Item 5.**Development Application: 12 Toxteth Road, Glebe - D/2019/1242**

File No.: D/2019/1242

The subject application is an amending development application to consent granted for D/2018/681/A.

Figure 19: Proposed Basement Section

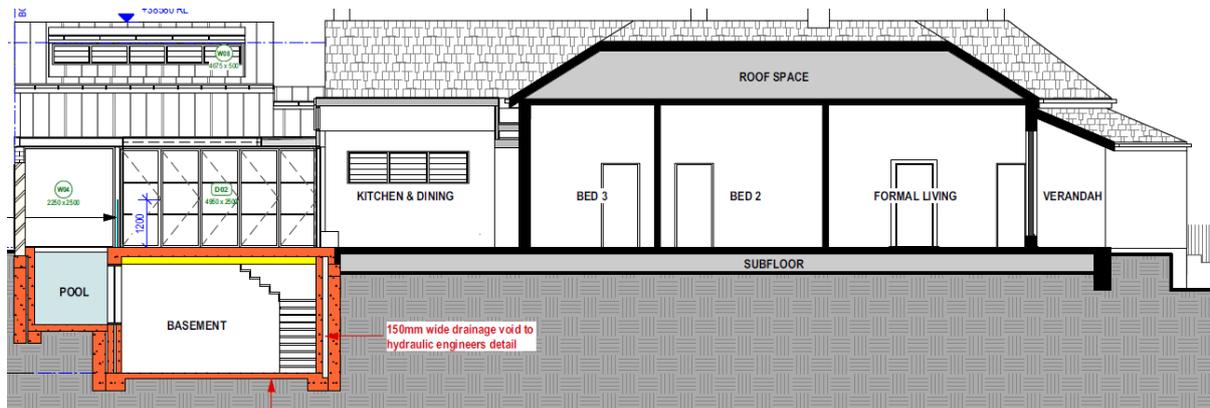
23. The proposal seeks consent for the excavation of the rear portion of the site to a depth of approximately 3.6m below existing ground level and construction of a new basement addition with storeroom and laundry/bathroom. The addition is approximately 60sqm of floor space. A section drawing of proposed basement is provided below:

26. It was noted in the preliminary review of the geotechnical investigation that the on-site testing for the water table had been to a depth of approximately 1.8 metres, and the proposed development is seeking to excavate to a depth of approximately 3.6 metres.

27. Clarification was requested from the applicant on 16 December 2019 on whether the depth of excavation proposed for the new basement level would penetrate the water table and require dewatering of the site.

28. Subsequently, the applicant sought additional testing and submitted an updated geotechnical investigation for groundwater assessment, prepared by 'Crozier Geotechnical Consultants' on 20 December 2019. The investigation concluded that;

'The borehole was drilled to 4.0m depth and groundwater was not encountered during drilling. Following the completion of drilling the borehole was left open for approximately 30 minutes prior to backfilling. Groundwater was not encountered during the drilling or within the open borehole.'

'Based on the groundwater conditions encountered during the drilling it is not considered that groundwater inflow will be encountered during excavation.'

29. Based on the updated investigation submission, it is considered that the proposed development will not penetrate or displace the water table, requiring dewatering of the site.
